Existing Pile Layout Plan and Damage Key Plan
September 20, 2024

I.L. GROSS
STRUCTURAL
ENGINEERS

PIILING PLAN & DETAILS, STRUCTURAL NOTES
35 UNIT APARTMENT
FOR THE HIGH DEVELOPMENT CO.
TO BE BUILT AT 6TH & BELL STREETS, RAYWALD WASH

PIILING PLAN
SCALE: 1/8" = 1'-0"

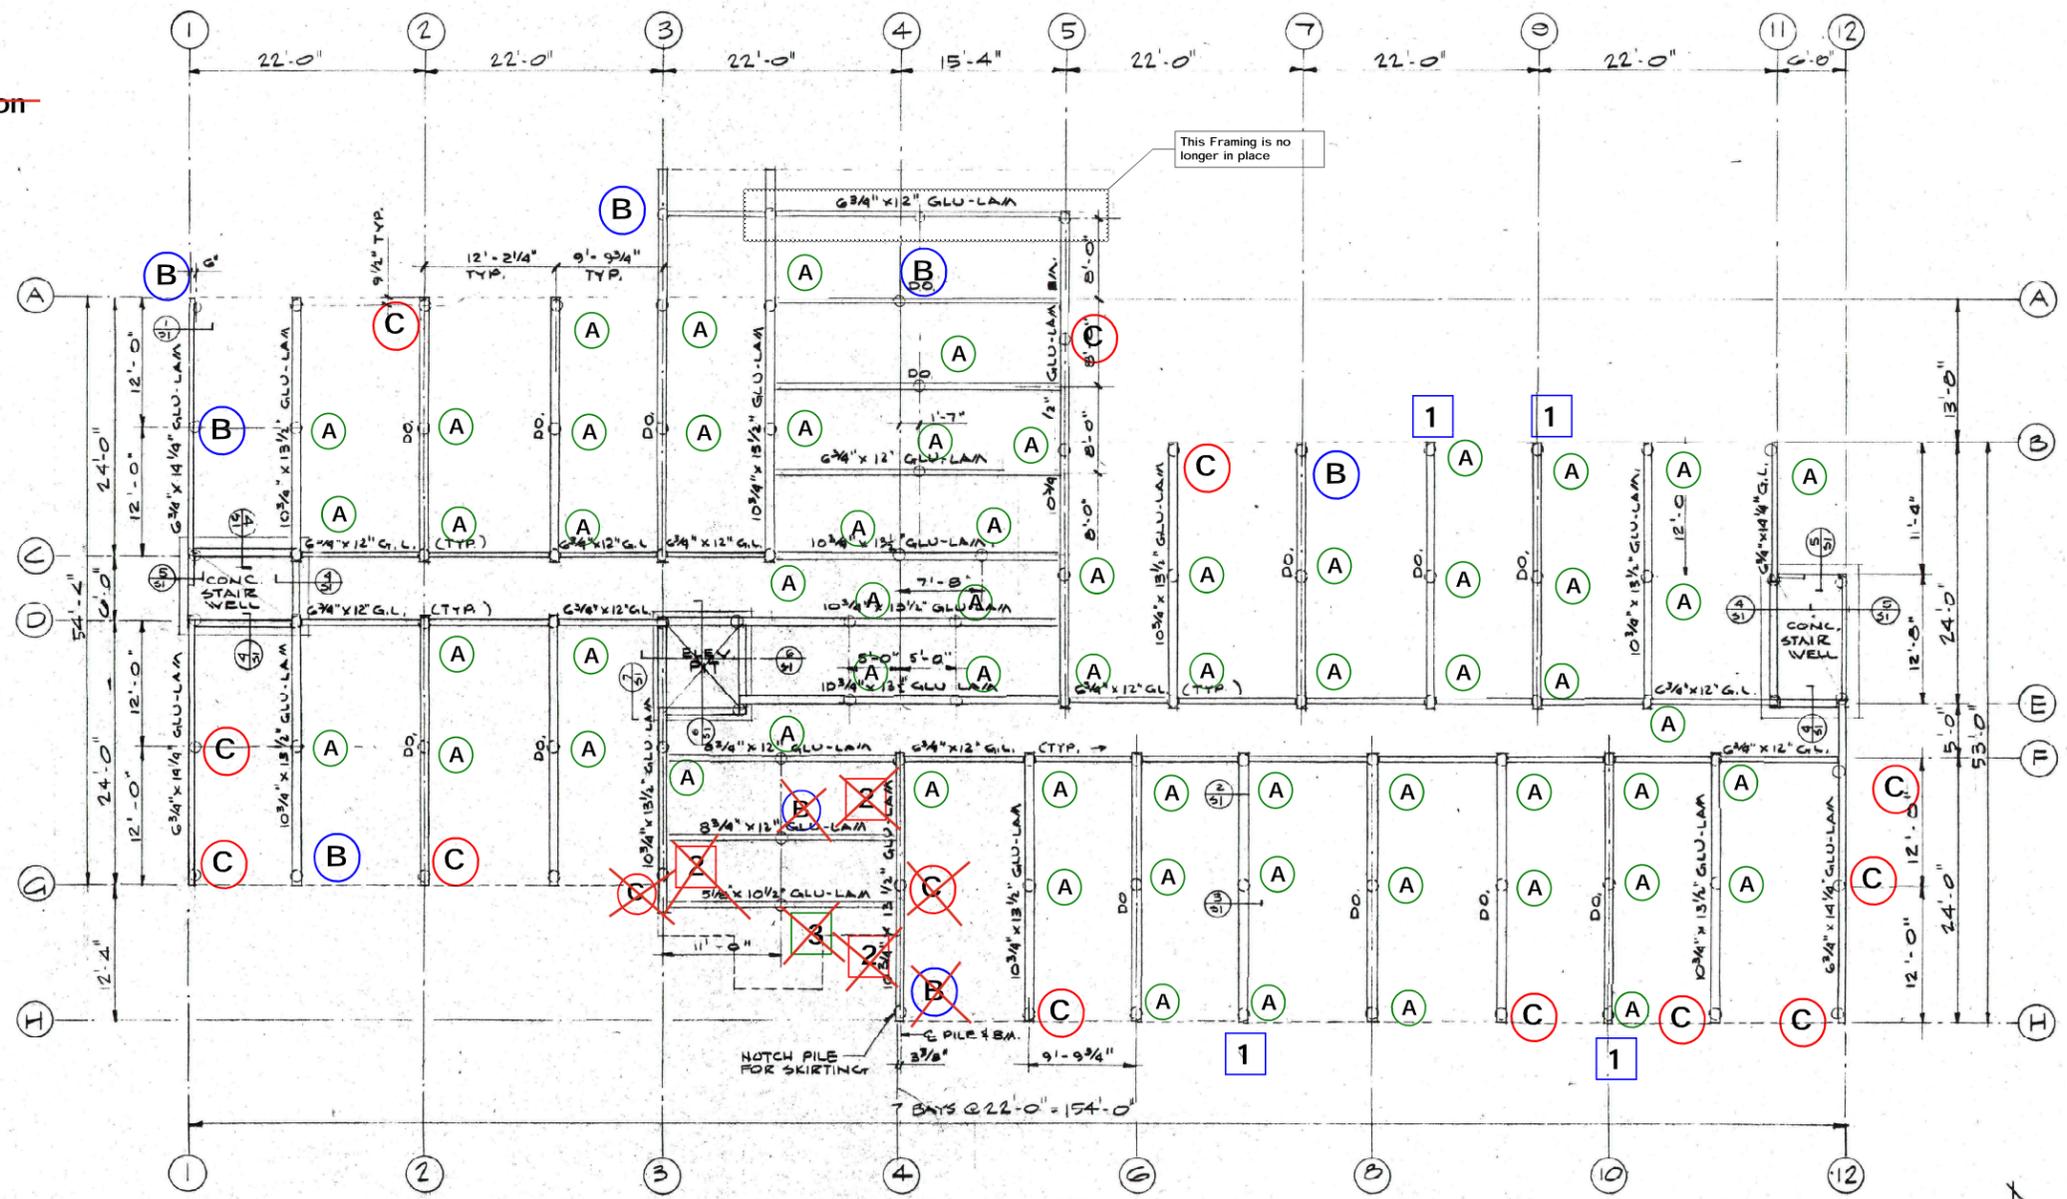
- (A) Pile is OK - Minimal Damage (Typical at all interior piles)
- (B) Pile has Some Rot, mainly above grade
- (C) Pile has significant Rot and likely needs to be replaced

- ~~1 GL Beam is offset from Pile CL~~
- ~~2 Beam has signs of Rot/Deterioration~~
- ~~3 Framing shows signs of Rot/Deterioration~~

BEAM repair completed 10/24
